RE: Arborist Assessment – Tree Protection Plan (TPP) – Revised Oct 2021

Location – 6922 Saanich X Road, Central Saanich – Subdivision

District of Central Saanich – Correspondence back to Client – October 18, 2024

Addendum #3 - Correspondence & Deficiency Listing - Received Nov 4th, 2024

Figure #1 – Trees #498, #499, #500, #288 & #289 – Lot #2 – Proposed Building Footprint

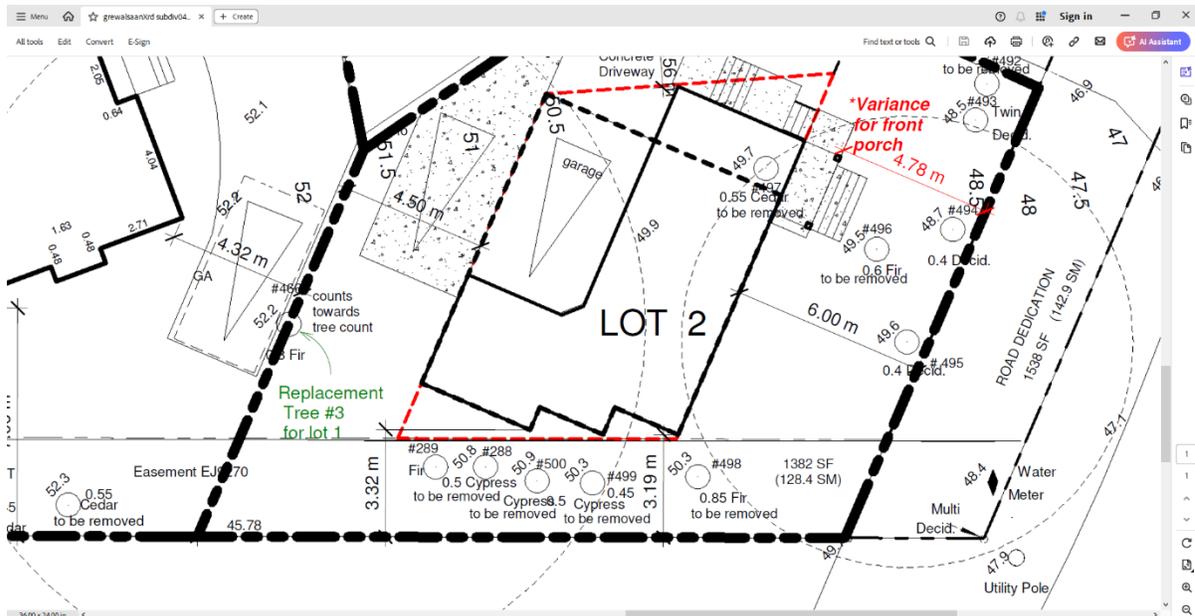
- An updated arborist report: Staff notes - Insufficient reasoning for removal of trees 498, 499, 500, 288, 289. Tree 483 could not be sufficiently protected for retention under the current plan. Reduction of parking spaces could allow for retention of several trees on all lots. Tree removal permit required for any permit trees to be removed. Tree protection for neighbouring properties must be installed and maintained prior to, and during any works. Review of plans for retention of permit trees on lots 2 and 3.

- Under the current proposal we highly recommend that trees #498-#500, #288 & #299 be removed due to anticipated excavation impacts. Each of the five (5) trees are positioned approximately 2m from the edge of the proposed building footprint for Lot #2.

- The excavation process will require at a minimum 0.5m of over excavation and therefore we expect that approximately 30-40% of each tree's Critical Root Zone (CRZ) will be removed and/or significantly impacted.

- A root loss of this magnitude for such large trees borders on the tree care industry tree retention threshold and therefore we are recommending that each of the five trees be removed due to post development failure probabilities.

- Combined with each tree's size, positioning and the development of new stationary "Targets" we believe that each tree would carry a residual risk of "High" in the landscape.

- The utilization of pruning mitigation (tree reduction) is not recommended due to extent of canopy loss that will be required.

Figure #1 - Lot 3 - Tree Protection Diagram

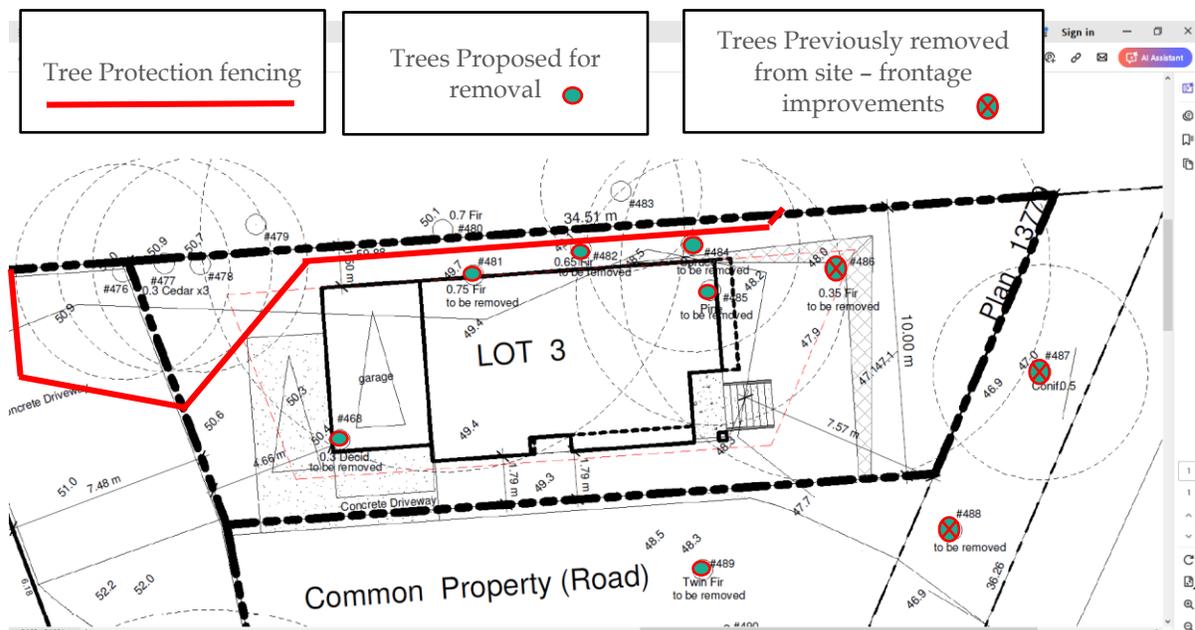
Trees no. 476, 477, 478, 479, 482, 484, 485, 488, 491, 492, 493, 495, 499, 500, 288 and 468 are all above 30cmdbh and are Permit Trees.

Was the site re-assessed after the sidewalk installation? Several trees were removed as per of that project. This will affect the tree removal totals for the site and if any trees have been removed that were to be retained, this will affect the replacement requirements. Tree protection may also be affected.

The SE corner of Lot 1 has a .55m cedar labeled for removal. This would require a permit and would need to qualify for removal.

1. Trees #486, 487, 488, and 495 appear to have been removed along the road frontage.
2. Tree #466 shared between lots 1 and 2 will be retained (counted as 1 replacement?)
3. 55cm No Tag Cedar on SE corner of lot 1 to be retained. (shown as remove on plan).
4. Remaining tree conditions appear to be unchanged from the original inventory. Remaining trees along the frontage have had excavation close to the stems for retaining wall construction. No significant roots were observed along the cut face of the bank. **Bank stability may be a concern.**

- Trees highlighted in red have been identified for removal.
- Eighteen (18) trees have been identified for removal.
- Sixteen (16) Bylaw Protected Trees are identified for removal.
- Staging is to be positioned in common property - Lot #1 & #2
